STAFF REVIEW AND RECOMMENDATIONS
PUBLIC HEARING
JUNE 21, 2023

ABBREVIATED PLAT: LAZY HUSKY

CASE #: 2023-062

SOIL LOG TH #1

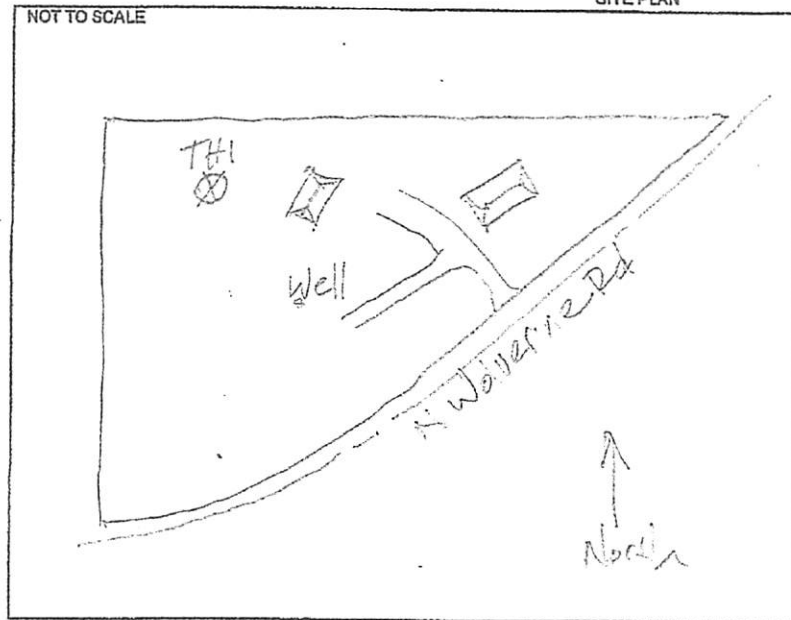
Comments: Department of Public Works Pre-Design Division (**Exhibit C**) recommends a shared access unless otherwise approved by ADOT&PF. A gradation or percolation test on Testhole #2 is needed (see **Recommendation #7**). Development Services (**Exhibit D**) has no comments.

PD&E comments a recommended shared access unless otherwise approved by DOT. A gradation or percolation test on test hole 2 is needed.

6. Provide proof of removal of existing driveway to Platting staff.
7. Provide a gradation or percolation test on Testhole #2.
8. Grant a 15' wide utility easement, as requested by MTA and ADOT&PF, by document. Show location and recorded information on final plat.

Figure 1. Vicinity map showing predominant drainage and well locations for Parcels C7, C15 and C22.

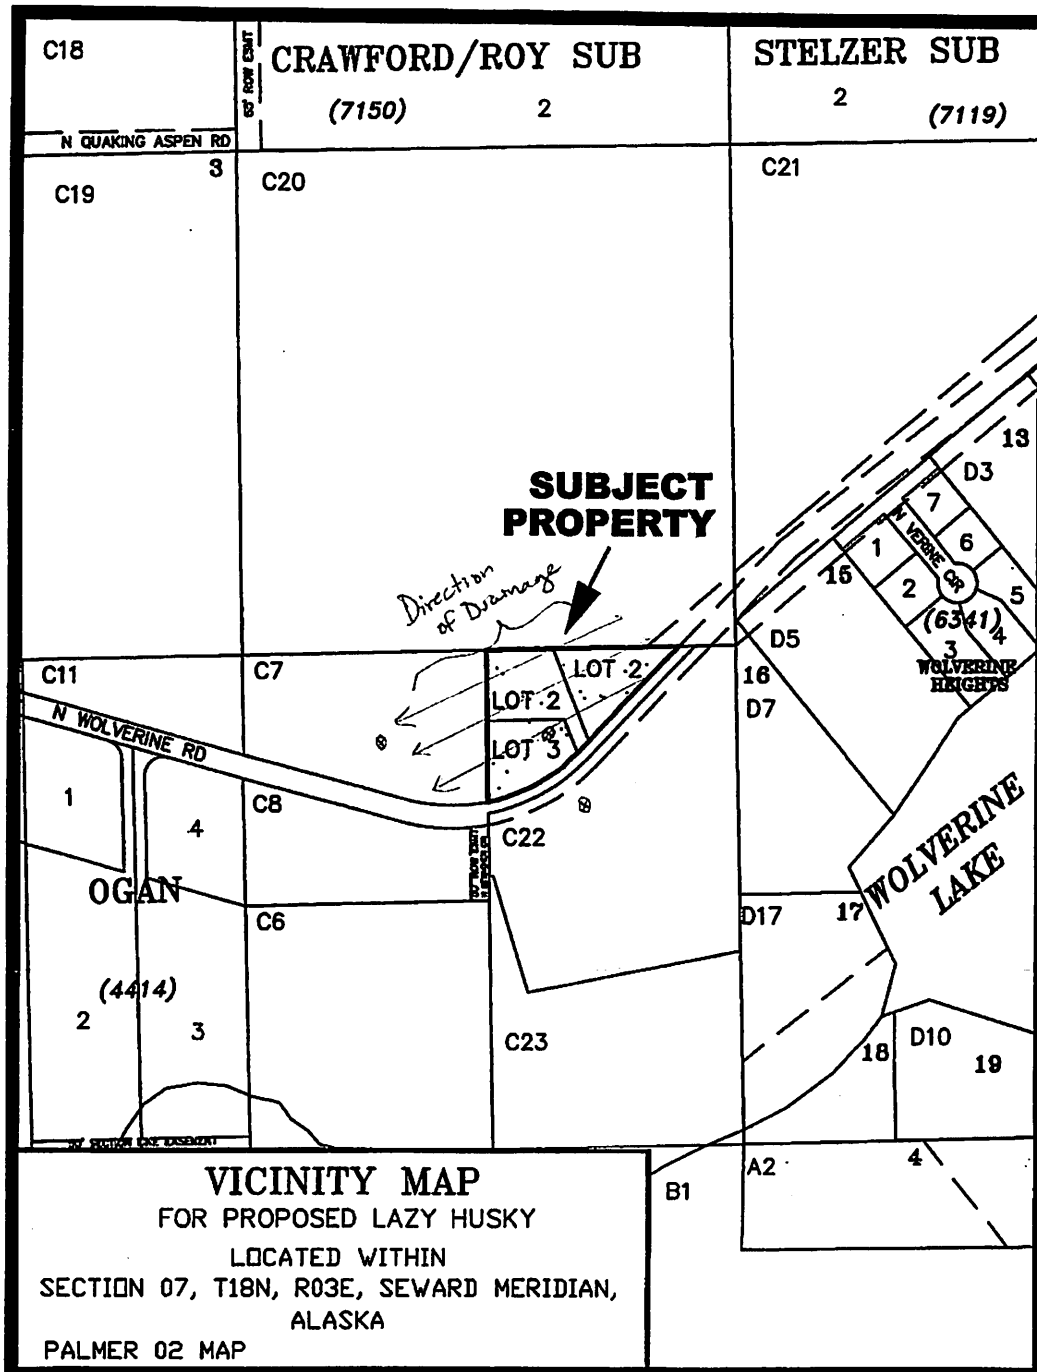
My primary objection is about drilling additional water wells at this location (Figure 1, well locations). The existing well on Parcel C15 is 267 feet deep. The water well on our property is 264 feet deep. It is well-known that well-drilling in this neighborhood is often very difficult and coming up with empty well borings is no uncommon. Often wells have limited flow with high particulate content in the water. Additional wells on Parcel C15 may impact the well on neighboring Parcels C7 and C22. The well log from our property (Parcel C7) shows the depth and the final recommendation to have a whole-house filter for our water (Figure 2).

The next major objection is for additional septic systems to be installed on Parcel C15. The slope of the land in this location drains directly from Parcel C15 to Parcel C7 (Figure 1, drainage). We regularly experience septic leach field problems during spring breakup, when our leach field floods from surface snow melt. Our septic percolation test revealed poor percolation at 23 minutes per inch (Figure 3). The subsurface soil includes clay and hardpan at depths from 10 to 45 feet. Water draining from leach fields are more likely to flow in near-surface soils than to drain into the hardpan, putting our property at risk of water contamination.
